has permission to Convert single Family Home

At 124 ALLEN AVE

City of Portland, Ma	ine - Buil	lding or Use	Permi	t Applicatio	n Per	rmit No:	Issue Date	:	CBL:	
389 Congress Street, 04		_				08-0309			342 B0	016001
Location of Construction:		Owner Name:			Owne	r Address:			Phone:	
124 ALLEN AVE		WOODWARI	D LORA	ALYN M	124	ALLEN AVI	Ξ		1	
		Contractor Name	r Name:		Contr	actor Address:			Phone	
		David Morash	1		124	Allen Ave Po	ortland		8023457436	
Lessee/Buyer's Name Phone:		Phone:			Permi	Permit Type:				Zone:
					Cha	ے دن inge of Owne	rship - Dwe	llings		R-5, R-
Past Use:		Proposed Use:			Perm	it Fee:	Cost of Wor	 k:	CEO District:	<u> </u>
Single Family Home 2 unit resid		1 -	ntial - Convert single e to 2 unit residential-			\$60.00 \$4,0		00.00	5	
					FIRE	FIRE DEPT: Approved INS		INSPE	CTION:	
		w/ tenant fit-u	p					Use G	roup: C 3	Type: 5B
						L	Denied		K	
					ĺ			-	roup:R3 [R4-20	03
Proposed Project Description:		L			┪			-	-11/2	. 1
Convert single Family Ho	me to 2 uni	t residential- w/	tenant f	it-up	Signat	ture:		Signati	enature: WBb/11.6

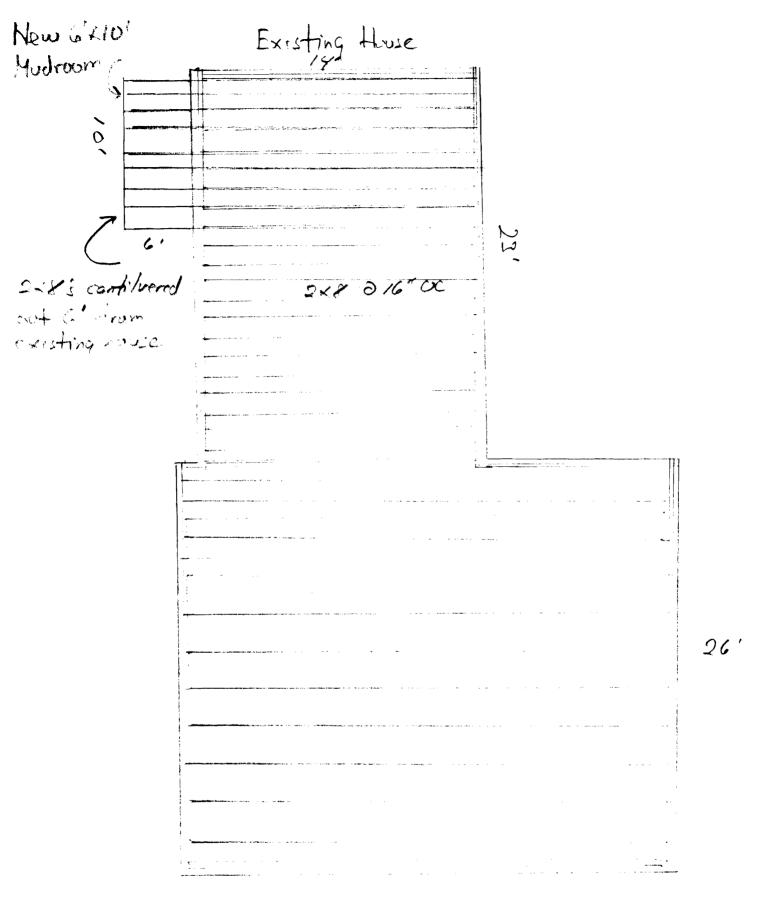
1. The stair does not show a landing at the bottom....is the door swinging in or out?

2. Need detail on the steps to the mudroom including guardrail/handrail design. (Note: handrail ht. is 34-38", but the guard for fall protection required to be 36"

4. Clarify fire/sound separations between the apartments and in the common areas. This needs to be a UL rated assembly, including the front hall.

Proposed Fire Protection: At front and rear entry/egress (see sketch) walls will be constructed of 2x4's @ 16 OC with 5/8" type X, fire resistant drywall with a 60 minute fire resistant rating. Doors will be fully insulated, steel entry doors.

I drew up more details. As we discussed, the bottom landing for the stairway will be part of the mudroom. I did the calculations and it will work. The main entry door to the 2nd floor unit will be on the gable end on the mudroom and the door will swing in.

Mudroom Addition - Front View 6'x10'

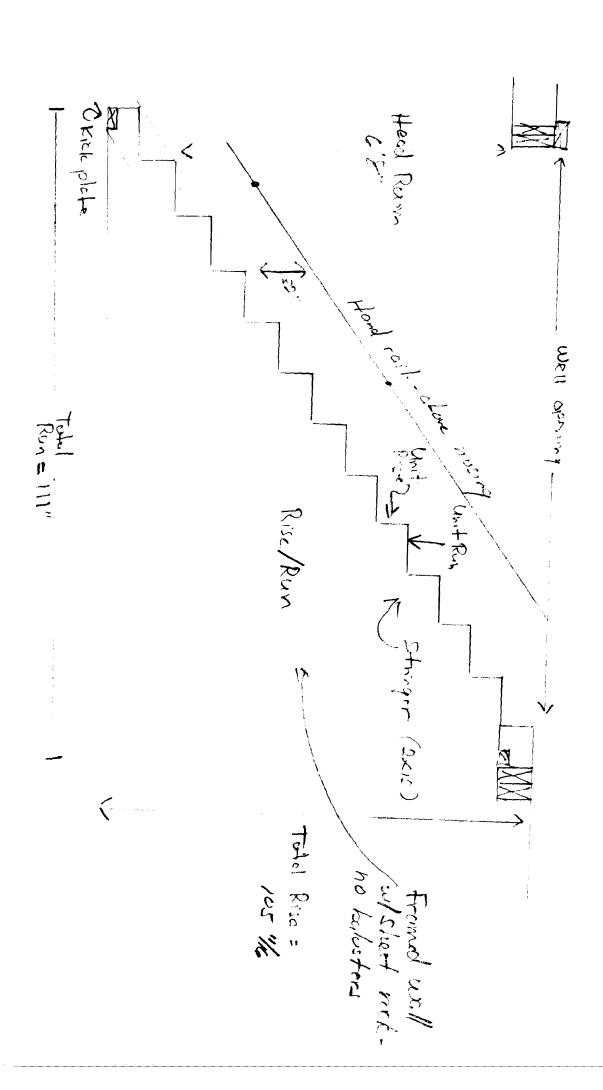
Dimensions of the supporting girder for the mudroom

3. Dimensions of the supporting girder for the mudroom

The Mudroom Detail: We will not cantilever the room

There will be 3 cement posts, 48" in-ground We would like to make the mudroom 6' x 12' instead of 6' x 10'

Subject: 124 Allen Ave ceiling/floor detail

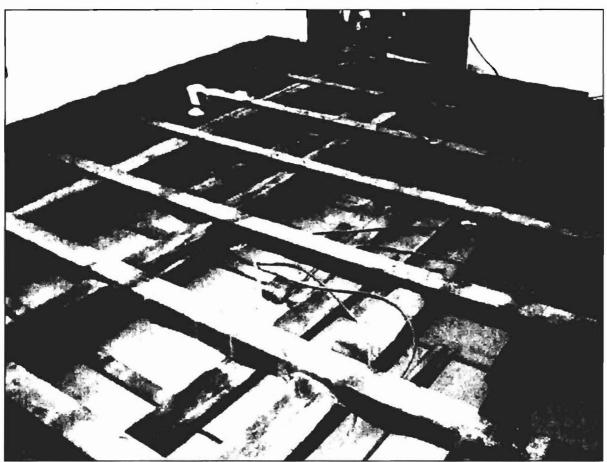
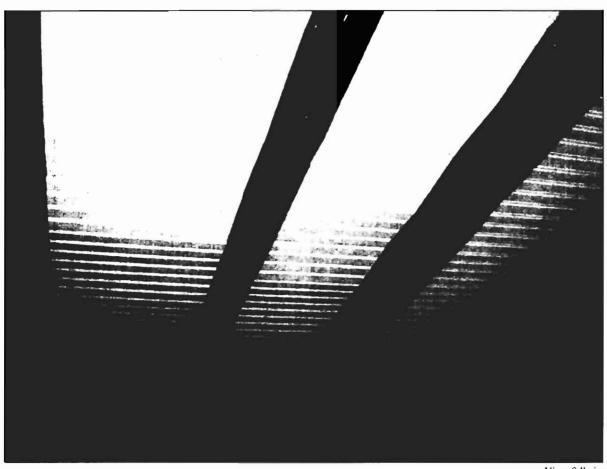
Ok, so this is not really creating a 1 hour separation because the wood beams/joists are exposed giving an unprotected path for fire.

Thanks....are you removing sheetrock in the kitchen and applying new? That's what it sounds like if you are insulating. If that is the case, you will also need metal resilient channel strapping for sound rating.

Ok, so I understand, all the floor area in the 2nd floor unit will be treated as you descibe from above, except the kitchen floor, which will have 5/8 x from below?

Currently, the joists are exposed above the kitchen. I will remove beadboard, insualte and rock with 5/8 fire code rock plus the metal resilient strapping. The joists will no longer be exposed. Will this meet the 1 hour separation?

That is correct. I will install fire coded sheetrock from above except in the kitchen which will be insulated and rocked with 5/8 rock from below
